PCI-SIG ENGINEERING CHANGE NOTICE

TITLE:	OCuLink BP Type ECN
DATE:	September 15, 2017
AFFECTED DOCUMENT:	OCuLink Specification version 1.0
SPONSOR:	Jay Neer (Molex), Alex Haser (Molex)

Figure 2-x. Upstream/ Downstream Port Assignment

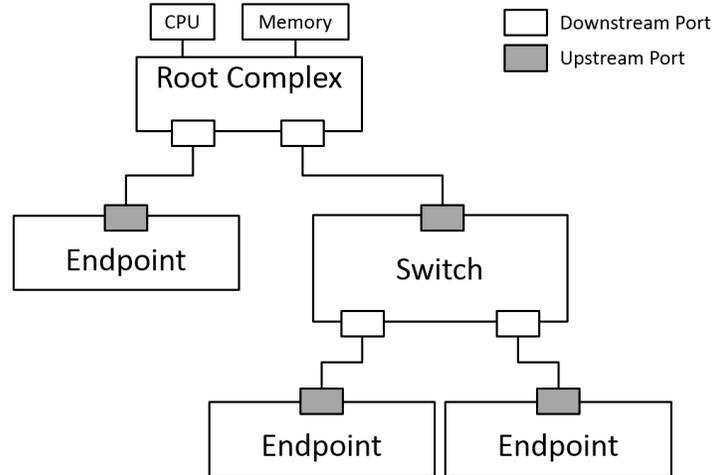
Upstream/ Downstream port assignment is defined as shown in Figure 2-x below. This naming convention is consistent across all PCI Express documentation. Refer to the *PCI Express Base Specification* for more information.
